# Phoenix Gatlin Center Major Site Plan Amendment Application P14-136-A1

SUMMARY			
	This is an application for approval of a Major Site Plan amendment to		
	make a significant change to the elevations of an office and retail use		
Applicant's Request:	building that was previously approved, but not built.		
Applicant:	Brad Curry, Engineering, Design & Construction (EDC, Inc.)		
Property Owner:	Gatlin Blvd., LLC.		
	The property is located on the south side of SW Gatlin Boulevard, east		
	of SW Dinner Street, and west of SW Port St. Lucie Boulevard. This		
Location:	property is located directly east of the existing Goodwill building.		
Address:	1070 SW Gatlin Blvd.		
Project Planner:	Holly F. Price, AICP, Senior Planner

**Lot 2 - Proposed Building Elevations**

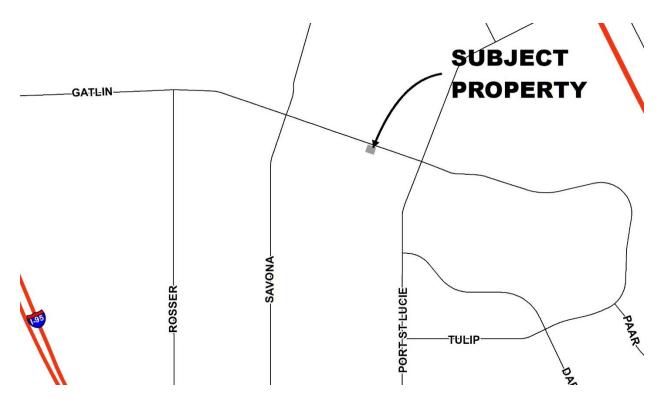
This is an application for approval of a Major Site Plan amendment to make changes to the building elevations. As per Section 158.237 of the Zoning Code, significant changes to the architectural style of a building require approval from the City Council. The applicant is proposing to change the design of the front, side, and rear facades and to change the roof from flat to a pitched.

The next page shows the proposed elevation modifications for this site. The applicant is proposing to change the design of the front, side, and rear facades - and to change the roof from flat to a pitched.

Planning and Zoning Department staff has reviewed the application to modify the building elevations. The Planning and Zoning Department staff finds the request to be consistent with the direction and intent of the City's Land Development Regulations and policies of the Comprehensive Plan and recommends approval.
